UNITED STATES PATENT AND TRADEMARK OFFICE

Office Action Summary

10/777,264

HAN, DAISY

FIG. 3A

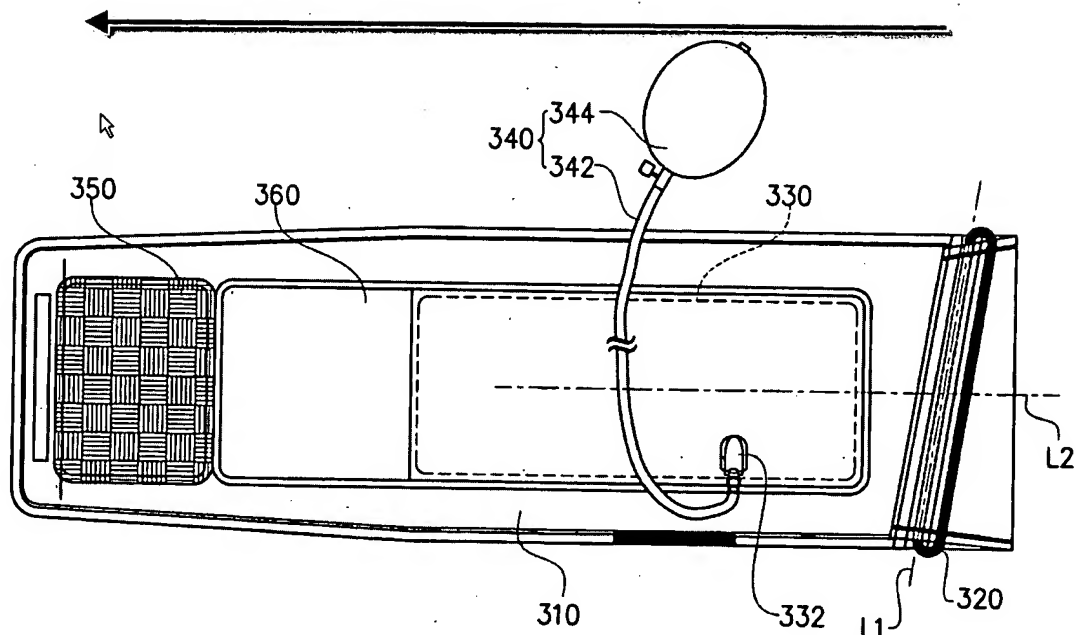
The amendment filed 7/18/07 is objected to under 35 U.S.C. 132(a) because it introduces new matter into the disclosure. 35 U.S.C. 132(a) states that no amendment shall introduce new matter into the disclosure of the invention. The added material which is not supported by the original disclosure is as follows: "strap unit 310 with a uniform width". The applicant states that the amendment to paragraph 18 is amended to include features shown in fig. 3a (see p. 6 of the remarks filed 7/18/07). Figure 3a has been reproduced below with an added arrow. Figure 3a does not show a strap unit having a uniform width, but does show a strap having strap whose width narrows slightly in the direction of the arrow. Nowhere else does the applicant's specification address the width of the strap. Applicant is required to cancel the new matter in the reply to this Office Action.

The amendment filed 7/18/07 also includes the following added material which is not supported by the original disclosure: "the strap unit 310 with . . . a free end and a folded end" and "the ring unit 320 is embedded in the folded end of the strap unit 310". The applicants cannot rely upon figure 3A to show support for this added material, since figure 3A does not clearly that the end of the strap having the ring is "folded", nor does the specification state that this end is folded. Furthermore, paragraph 24 of the specification states, "one end of the strap 310 passes through the ring and is folded back for the first adhering region 350". It appears that the end of the strap that is so "folded" is not the end having the ring. Applicant is required to cancel the new matter in reply to this Office Action.

Each of claims 1 and 5 recites "a strap unit with a uniform width". The instant specification lacks support for such a strap having a uniform width. As explained above, figure 3A of the instant application, in fact, shows the strap having a non-uniform width.

Each of claims 1 and 5 further recites, "a strap unit with . . . a free end and a folded end; a ring embedded in the folded end". The instant specification lacks support for such a strap having a folded end and a free end, wherein the ring is embedded in the folded end. While figure 3a shows the ring being embedded in an end of the strap, the end is not disclosed as being "folded" nor does figure 3a clearly show such a fold.
